R22 SERVICE LETTER SL-59

SUBJECT: MRGB Oil Level Fluctuation

ROTORCRAFT AFFECTED: R22 helicopters S/N 4442 thru 4509, unless previously accomplished.

FIGURE 1

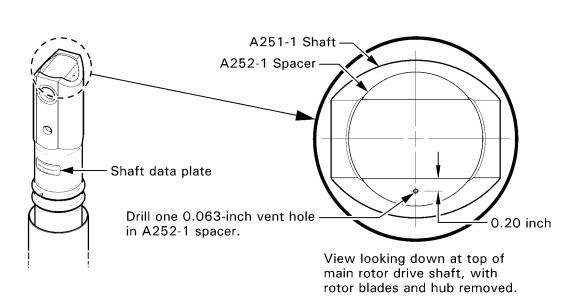
BACKGROUND: RHC has received reports of oil level fluctuating in main rotor gearboxes with sealed drive shafts. During cooling after flight, low pressure inside a sealed shaft may draw oil up into the shaft and affect oil level indication. If oil level fluctuates, a vent hole may be drilled in the aluminum spacer at the top of the shaft to equalize pressure.

- 1. Refer to Figure 1. If data plate indicates A251-1 shaft is revision T (or subsequent), or if A251-1 revision S (or prior) shaft's data plate is marked with a yellow paint dot, the recommendations of this letter have been complied with and no further action is necessary.

- 4. Refer to Figure 1. Mark hole location in A252-1 spacer as shown; remove sealant as required.
- 5. Vacuum debris while drilling and slowly drill 0.063-inch diameter hole thru spacer (material is 0.060 inch thick aluminum; adjust drill stop accordingly).

- 6. Mark shaft data plate with yellow paint dot in upper left corner.
- 7. Install main rotor hub per MM § 9.122.
- 8. Install main rotor blades per MM § 9.112.
